*issues***NOTIFICATION BULLETIN No. RTC-051b R1**

- 1. CONCERNING TO:** All airplanes SPORTSTAR RTC except airplanes SPORTSTAR RTC S/N 20151729, Reg. N. OE-ASA and S/N 20192112, Reg. N. S5-DNK (on these airplanes, the exhaust pipelines were installed by means of the bulletin No. RTC-044b).

- 2. REASON:** Based on the experience from the operation of the airplanes, the airplane manufacturer allows the installation of modified exhaust pipelines Dwg. No. E6 18-23 01, E6 18-24 01, E6 18-25 01, E6 18-26 01. A major benefit, leading to increased life of the exhaust system, is to increase the wall thickness at the location of the ball joint where the original version has a wall thickness of approximately 0.4 mm and the modified version has thickness 1 mm.

Fig. 1 – Exhaust system

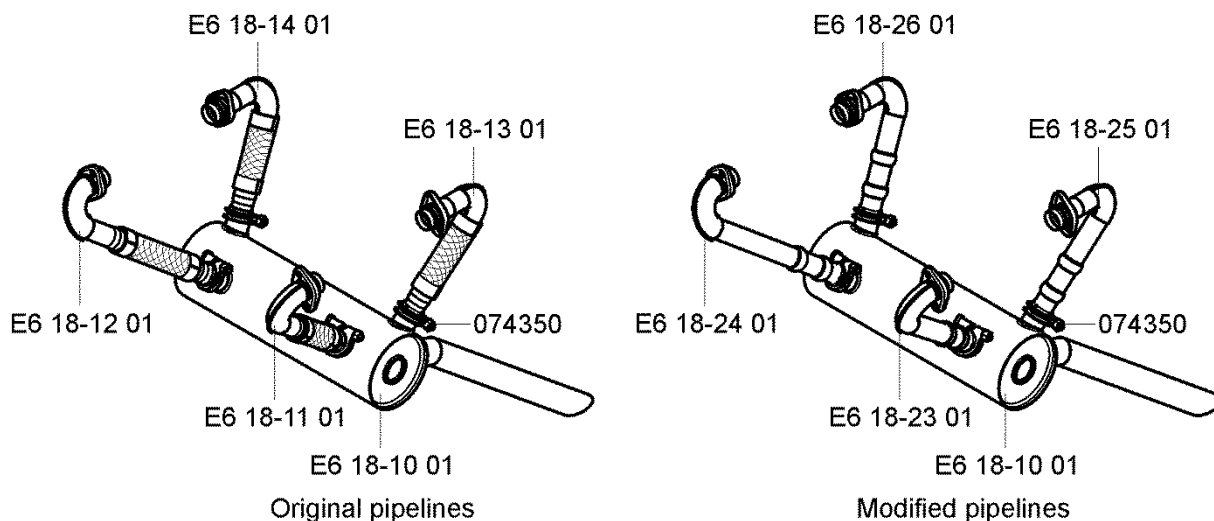
The modified exhaust pipelines differ from the original exhaust pipelines by replacing the flexible parts of individual exhaust pipeline with the new hydro-formed pipeline with ball joints.

The geometry of the whole exhaust system, the exhaust collector, the cross-section of the pipeline, the length of the flue gas routes and the way of installation in the airplane do not change.

NOTE: Modified exhaust pipelines are only compatible with E6 18-10 01 exhaust collector.

Fig. 2 – Exhaust system – removal / installation

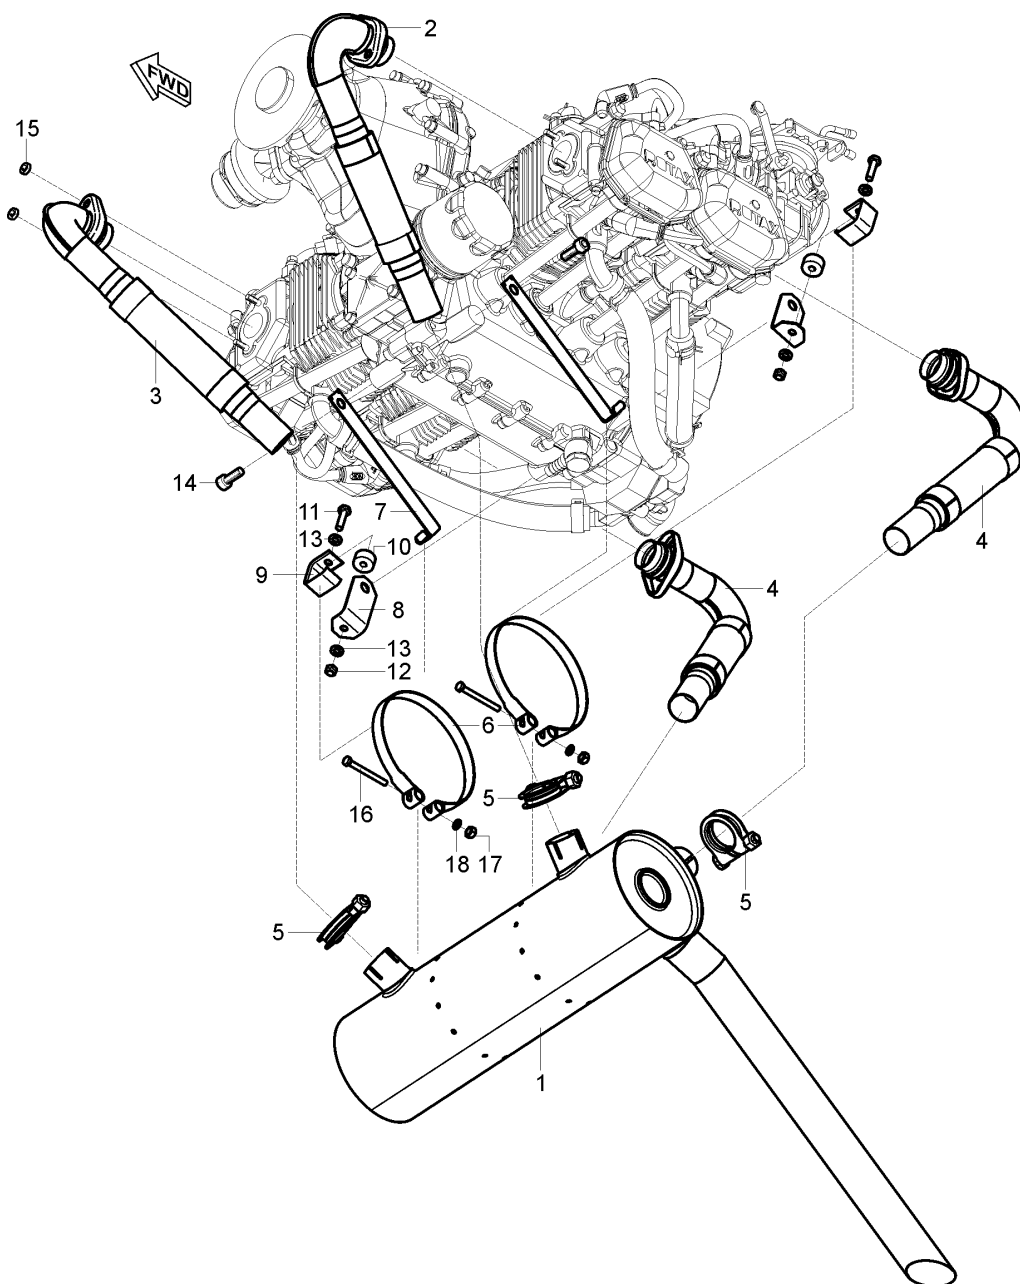
- a) Check the individual parts of the exhaust system to make sure that they are not damaged, burnt or torn.
- b) Install the shock-absorbers (10, Fig. 2) between the brackets (8; 9) and attach them with screws (11), nuts (12) and bushings (13); do not tighten the nuts.
- c) Attach the front brackets (7); slightly tighten the screws (14).
- d) Remove the end caps from the openings in the cylinder heads.
- e) Attach the heat exchanger to the muffler according to the procedure mentioned in the Aircraft Maintenance Manual for Sportstar RTC (doc. No. ERTC022-10-AS), Section 21-40.
- f) Attach the muffler (1) to the brackets (7; 9) with clamps (6), screws (16), nuts (17) and washers (18); do not tighten the nuts.
- g) Put the sleeves (5) on the muffler socket pipes (1).

- h) Align the exhaust pipelines (Fig. 3) in the straightened position.
- i) Slide the individual pipes (2, 3, 4, Fig. 2) on the muffler socket pipes (1); align the flanges on the cylinder heads, screw on the nuts (15) and tighten them slightly.

- k) Tighten the sockets (5), nuts (12; 17) and screws by (14) with the prescribed torque of 8-10 Nm.
- l) Tighten the flange nuts (15) with the prescribed torque of 15 Nm.

- m) Check the shock absorbers (10). When tightening the exhaust pipeline clamps, the shock absorbers may be compressed and need to be tightened.
- n) Secure the screws (14) and fasteners of the clamps (16; 17) with a lockwire according to the procedure mentioned in the Aircraft Maintenance Manual for Sportstar RTC (doc. No. ERTC022-10-AS), Section 20-20.

Fig. 3 – Exhaust pipelines – the coaxial alignment

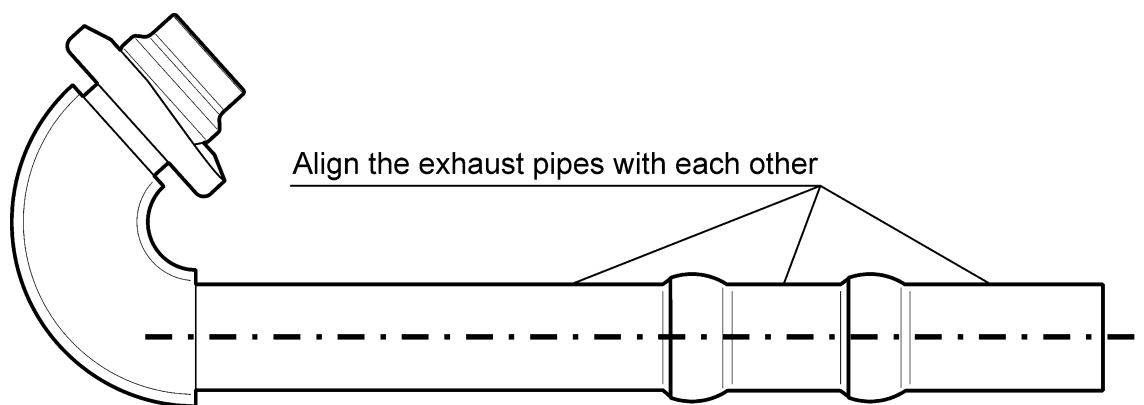
FIT THE MUFFLER BY ROTATION AND BY SHIFT THAT THE METAL HOSE OF THE EXHAUST PIPE MUST NOT BE DEFORMED AND COMPLETELY STRAIGHT AFTER SLIDE INTO MUFFLER SOCKET PIPES AND AT THE SAME TIME INTO THE ENGINE CYLINDERS. YOU MUST SLIDE THE PIPES INTO THE MUFFLER SOCKET PIPES SO THAT YOU CANNOT SEE THE GAP IN THE GROOVE OF THE MUFFLER SOCKET PIPE.
